PRODUCT CHANGE NOTIFICATION

Bourns® Model 2377 Station Protector Series

Change to Design and Marking Technology

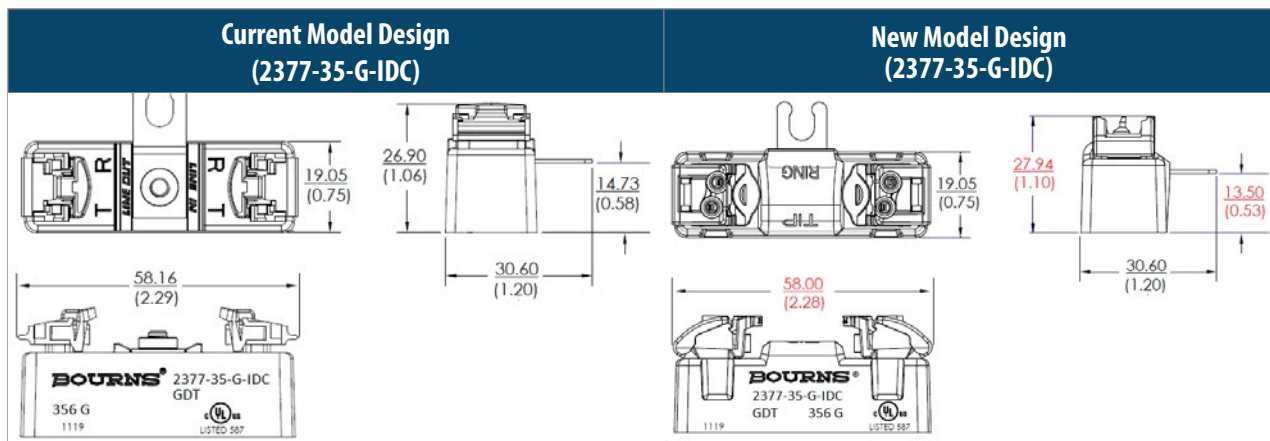
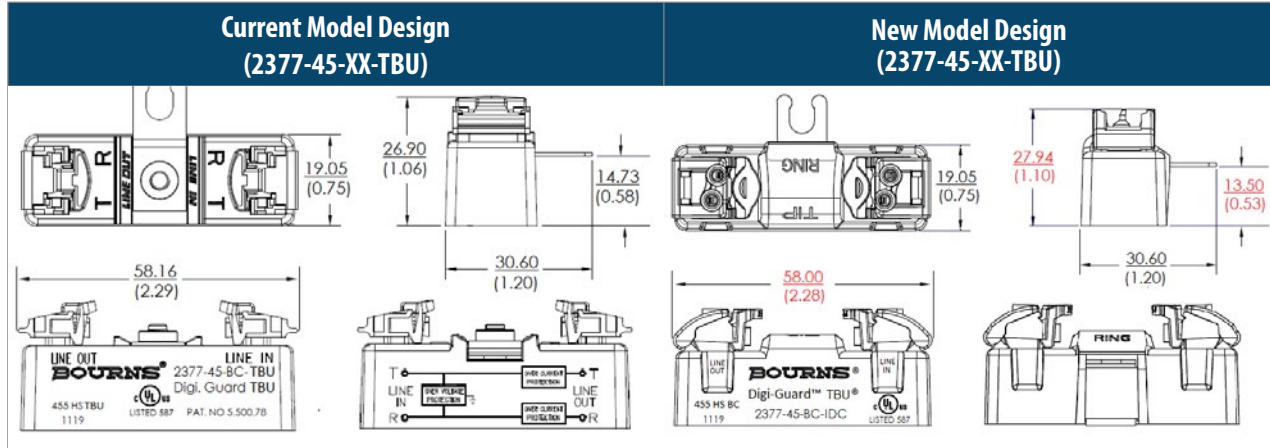
The form of the products will change slightly due to the new plastic housing, insulation displacement connectors and the height position of the ground terminal. The marking of the products will change from ink printing to a new laser marking. These changes will have no impact on the fit, function, quality or reliability of the product.
